Addendum No. 1

Las Acequias de Las Trampas Flume Rehabilitation Project

This addendum is issued to reflect the following changes to the contract documents dated May 6, 2024. This Addendum is effective January 17, 2025. It shall be the responsibility of all bidders to adhere to any changes or revisions to the Las Acequias de Las Trampas Flume Rehabilitation Project as identified in Addendum No. 1. This documentation shall become a part of the Contract Documents.

NEW MEXICO STATE HIGHWAY COMMISSION
 RIGHT OF WAY MAP
 NEW MEXICO PROJECT NO.
S-1513(5)
 TAOS COUNTY
 SCALE 1" = 50'
 SHEET 9 OF 12

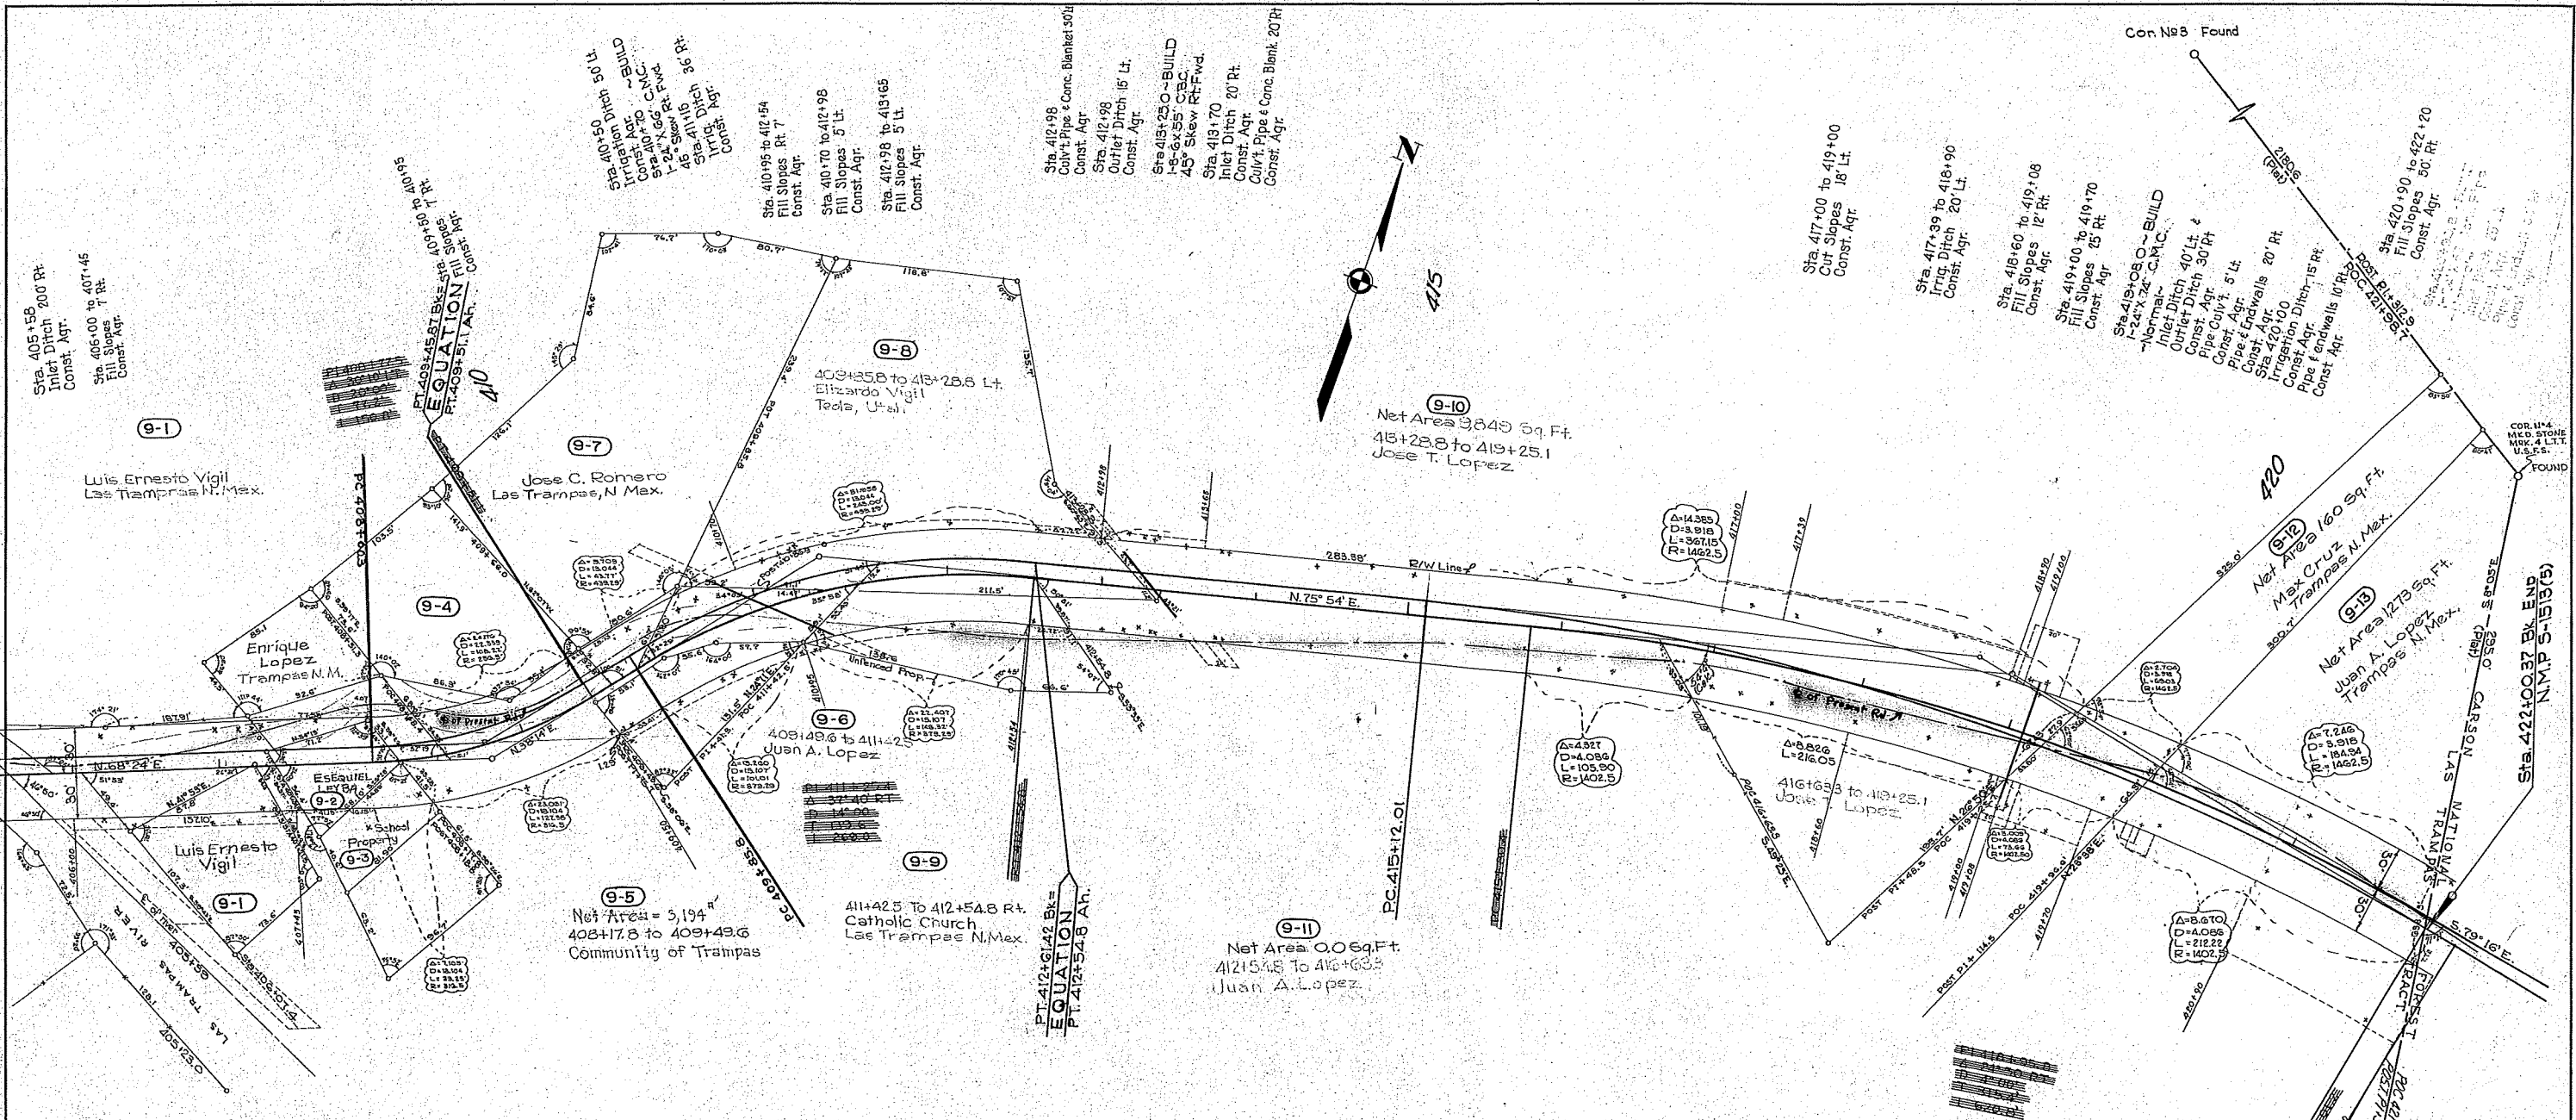
1. The sign-in sheet for the mandatory pre-bid meeting for **Thursday, January 16, 2025, is attached.**
2. Question: Is a traffic control plan required?
3. Answer: Yes, please see page Spec2, Construction Specification 8 – Mobilization & Demobilization, 4. Items of work and construction details which includes traffic control requirements. On sheet G1 of the construction drawings, in the Bid Schedule, the specification number for Bid Item No. 3 – Traffic Control Plan shall be changed from 9 to 8.
4. Question: Is the proposed structure located in the existing right of way for State Highway 76?

Answer: The proposed structures, including the outlet structure for the flume, are located approximately 31' from the highway centerline and are outside of the existing highway right of way (30' offset from road centerline, as shown in attached plat from NMDOT). However, it is anticipated that the Contractor may need to temporarily excavate into the highway right of way, to install the proposed outlet structure. At a minimum, the Contractor will need to obtain a Traffic Control/Roadway Work Permit for implementation of the Contractor's approved Traffic Control Plan. It will be the responsibility of the Contractor to contact NMDOT and obtain applicable permits if the Contractor must cause temporary disturbance to the highway right of way for completion of the work in the contract documents.
